BUREAU OF MINES

Memorandum

To: Truman Seamon, National Regulatory Commission, Washington, D.C.
From: Clarence O. Babcock, Supervisory Mining Engineer, Mine Design Division, Denver Research Center
Subject: Trip Report for May 17-19, 1982 Visit to NTS and Discussions with DOE

FIGURE 1. - SITE LAY OUT

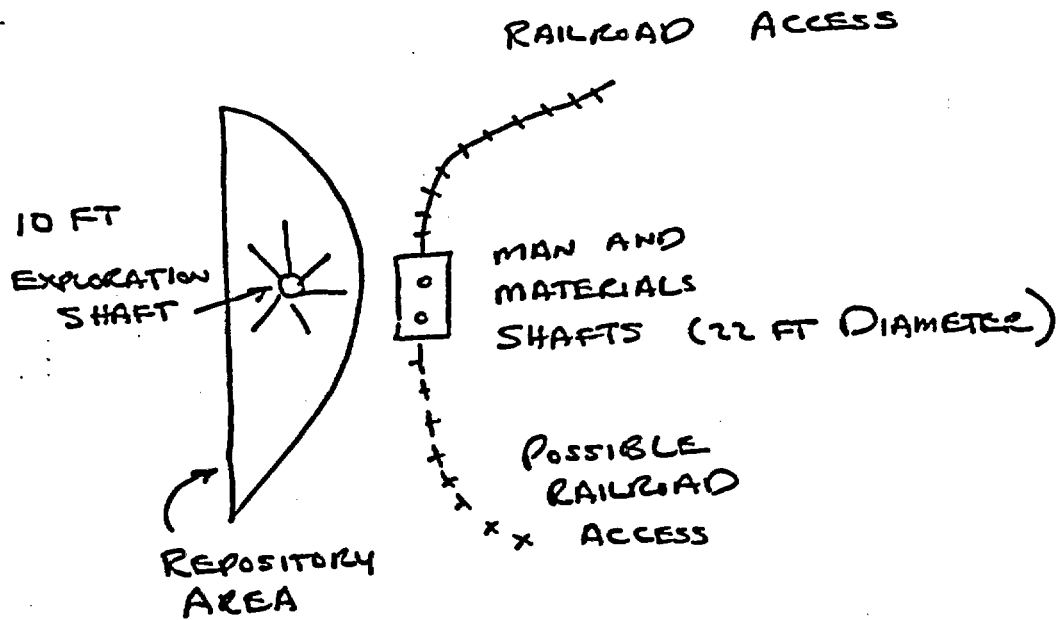
The most useful part of the meeting relative to the mining aspects was the presentation of Mr. Leo Scully, Sandia National Laboratory, who presented his conception for a mine layout in very broad and general terms in figure 1. He thought the shafts should be to the east of the repository zone. However, a shaft location on the west side was also considered. The access to the shafts should be by railroad probably from the north but perhaps from the south. An exploration shaft of 10 ft diameter would be sunk through the center of the repository horizon and ring drilling with 2,000 ft holes would be used to

FIGURE 2. - VERTICAL CANISTER EMPLACEMENT

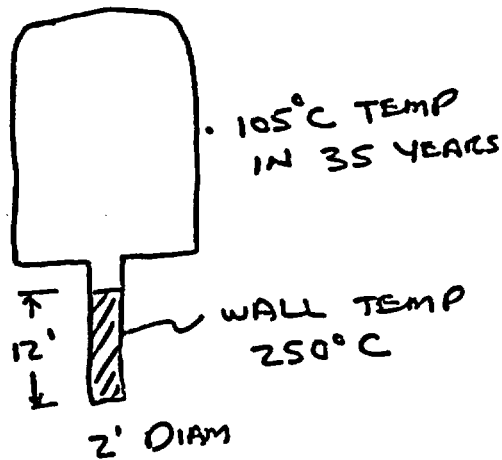
sample the rock mass over as large an area as possible. The men and materials and waste shaft would be of 22 ft diameter. He considered one scenario where the canisters would be placed vertically as in figure 2. They would produce an expected 2 Kw of heat per canister at a temperature of less than 400°C in the center of the waste and of 250°C in the rock mass. The wall temperature of the entry for placing canisters would reach 105°C in 35 years. The heat load would be 50-75 Kw/acre. Air conditioning with 24°C air at a flow rate of 1 meter/sec would reduce the temperature from 105°C to 40°C within 4 months when necessary for the operation of the repository. Another scenario shown in figure 3 which he preferred was as follows. Two parallel drifts driven 600 feet apart on the same elevation would be connected by parallel drill holes normal to the drift directions. These holes would be filled with canisters for the center part of the holes but would be left empty for a selected distance from each end of the hole. The heat buildup around the canisters would be isolated from the drifts by this unloaded zone. The isotherms would radiate out from the waste with time allowing perhaps 50 years during which the drift or entry temperature would be low enough for mining operations, waste emplacement, etc. The holes would not be backfilled so that the rate of temperature buildup would be decreased. A retrieval would be easier, if necessary.

FIGURE 4. - SECOND EXPLORATION SCENARIO

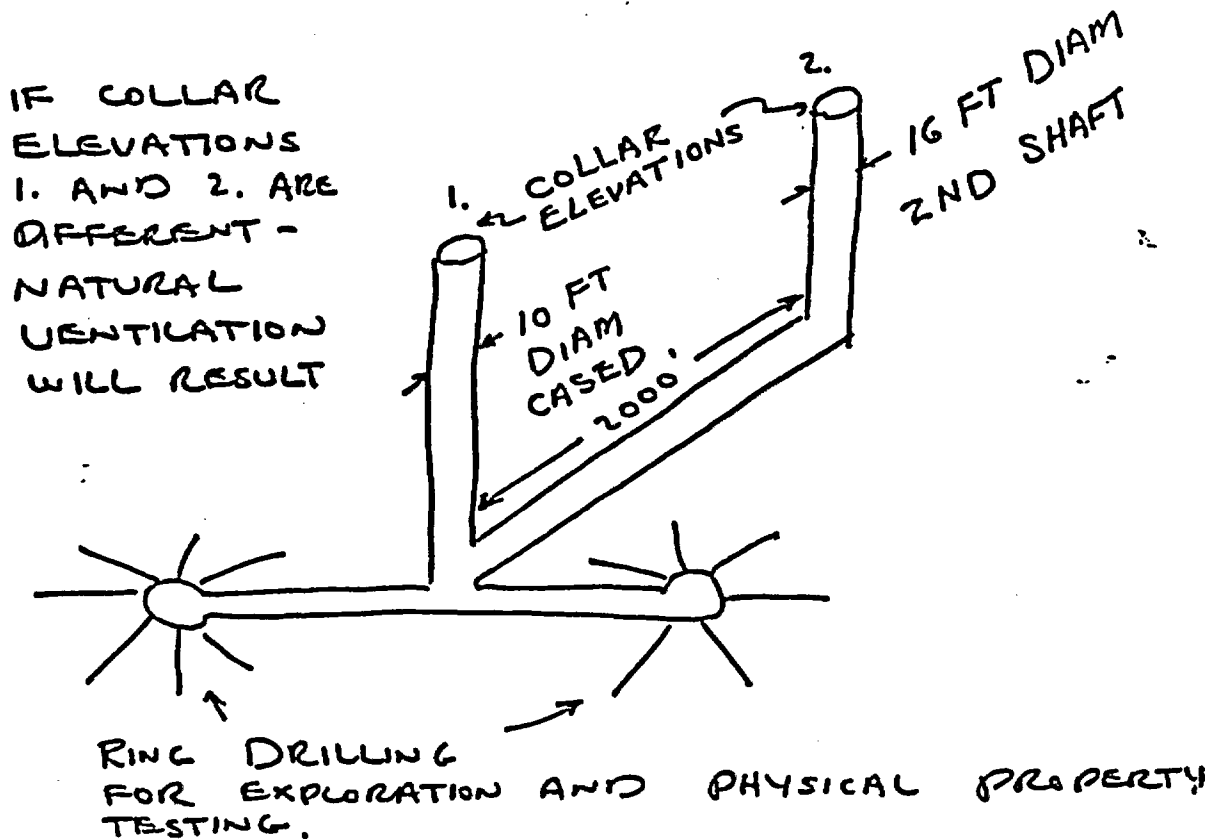
Another exploration scenario proposed (figure 4) was to sink a shaft of 10 ft diameter for the first phase, drive drifts 200 feet away from the shaft and then ring drill to define rock properties, extent, structural features, etc. Next, a second shaft of 16 ft diameter would be sunk 1,500 to 2,000 feet deep and connected to the first shaft. One item of interest was the use of natural ventilation to help cool the repository by using two shafts with collar elevations as different as possible, say 700 to 800 feet. Natural ventilation is as old as mining itself but is seldom counted on for ventilation in modern mines.

ABSOLUTE PRESSURE OF DRY SATURATED STEAM VS TEMP. °C

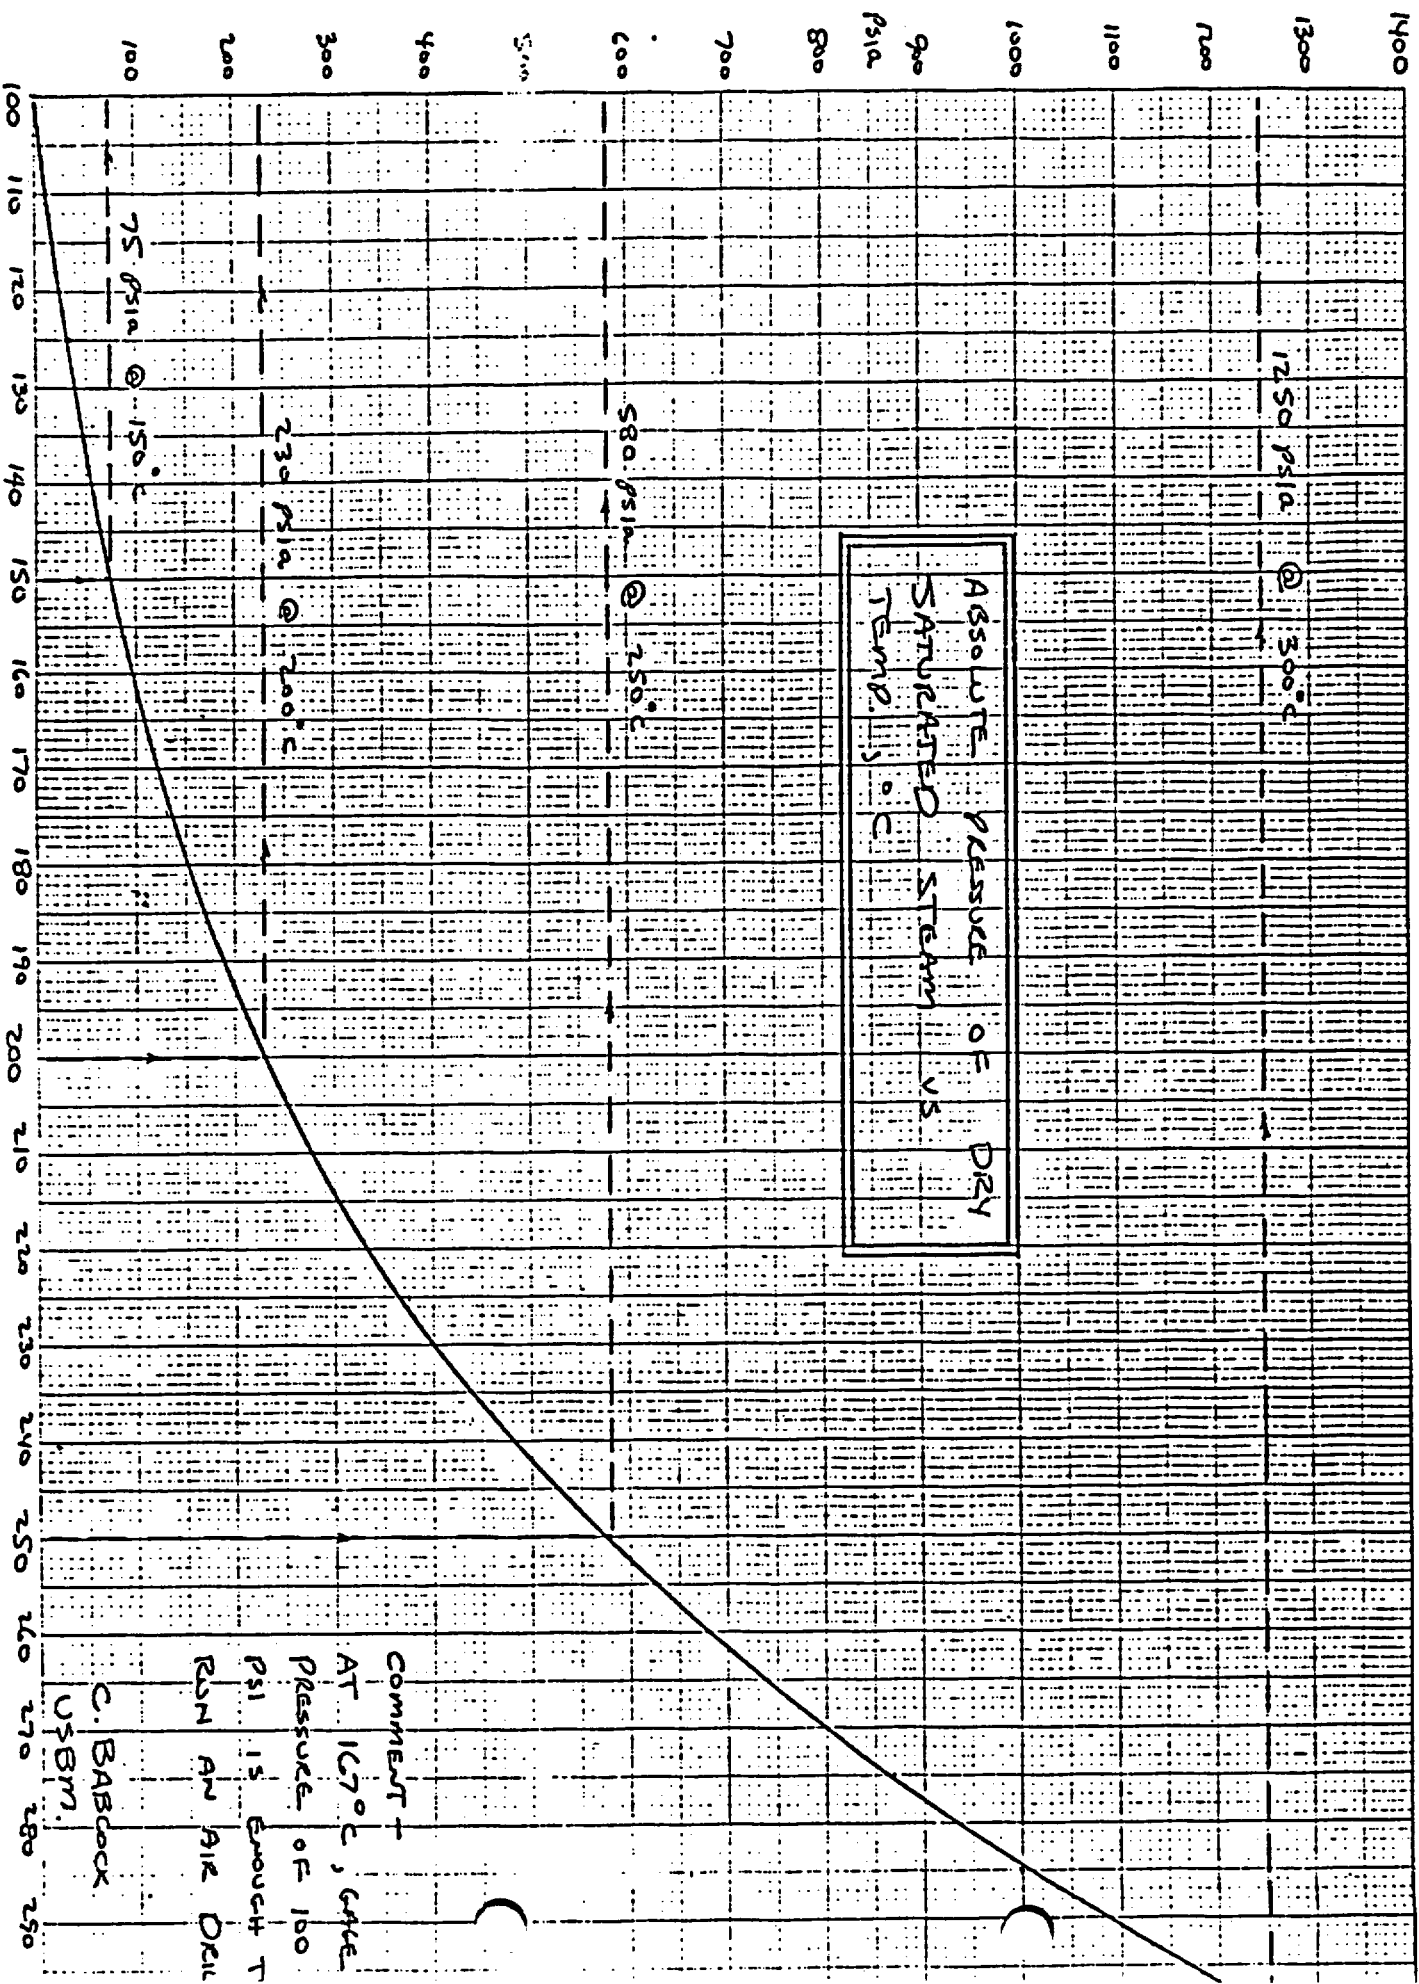
Since mining in a rock mass with a temperature perhaps 200°C has not been done and the problems, including pressure buildup, cannot be ignored, I see little value in making heater tests as Sandia is doing with temperatures of 90°C. A graph of pressure versus temperature for water-steam is attached.

COMMENT -
 AT 167°C, GATE
 PRESSURE OF 100
 PSI IS ENOUGH TO
 RUN AN AIR DRILL
